STAFF REPORT

APPLICATION: AGENDA ITEM I.4
SEPTEMBER 26, 2024 MEETING

Re: **IWWA Application: 108 Chamberlain Lane**
One lot subdivision and site plan: Single Family House and Septic System

Re: Re-subdivision of 108 Chamberlain Lane
for New Residential Dwelling

Location map showing wetland soils (from aerial) in **red**, existing conservation easement in **green** and sanitary sewer easement in **brown**. Wetland boundary shown is consistent with field located wetland soils.

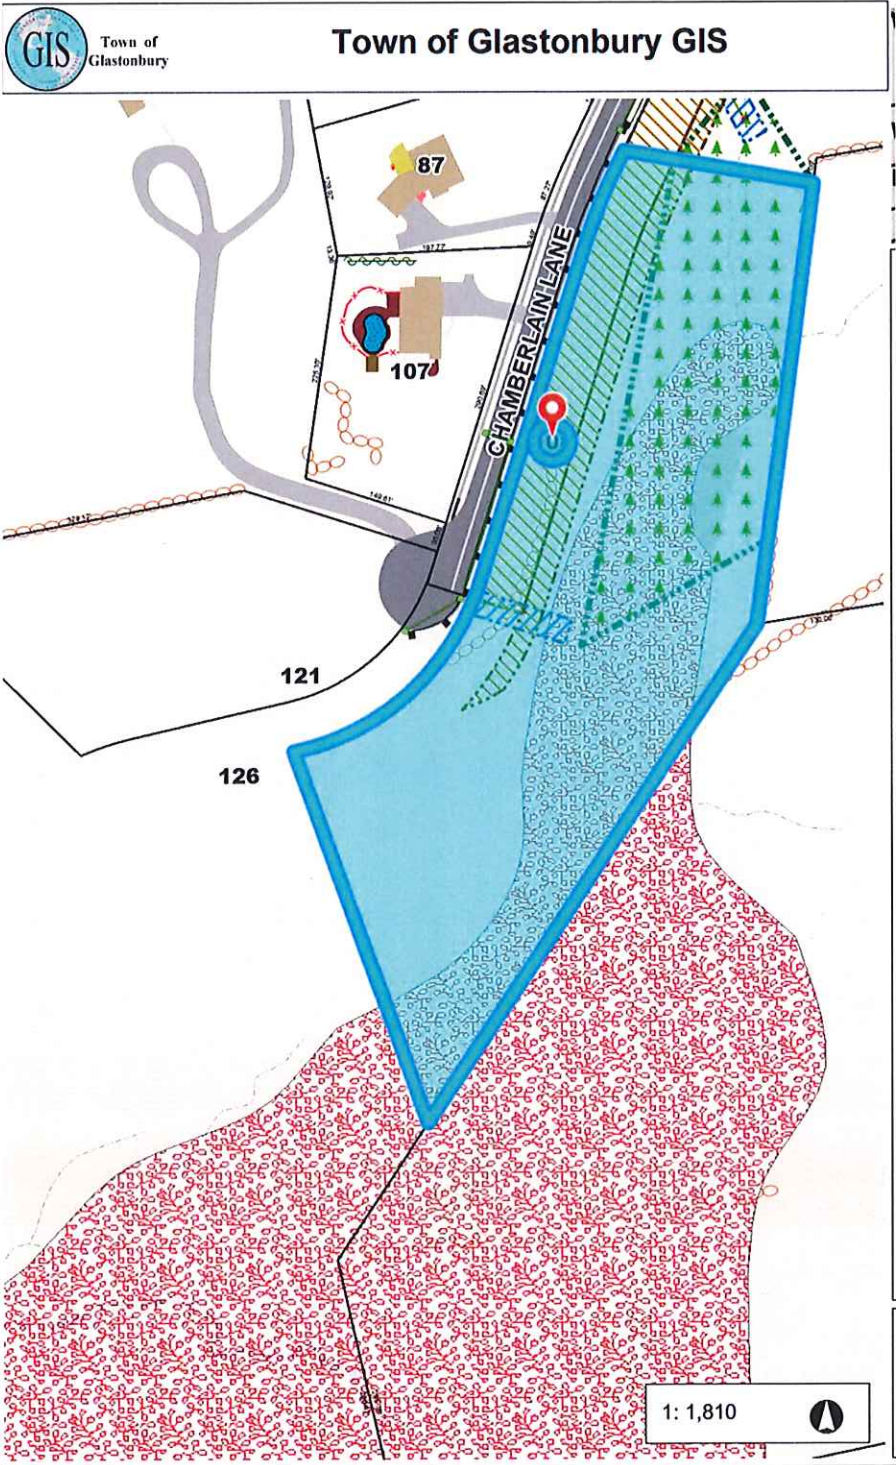
The property contains a conservation easement to the northeast. The 2020 field delineated wetland is consistent with the town soil map. Development is proposed within 20’ of the delineated wetland, to accommodate the corner of the proposed house and walk out basement. This property is located within the Grindle Brook watershed, which is a 150’ upland review area. The proposal includes the creation of a conservation easement to envelop the wetland area (Sheet
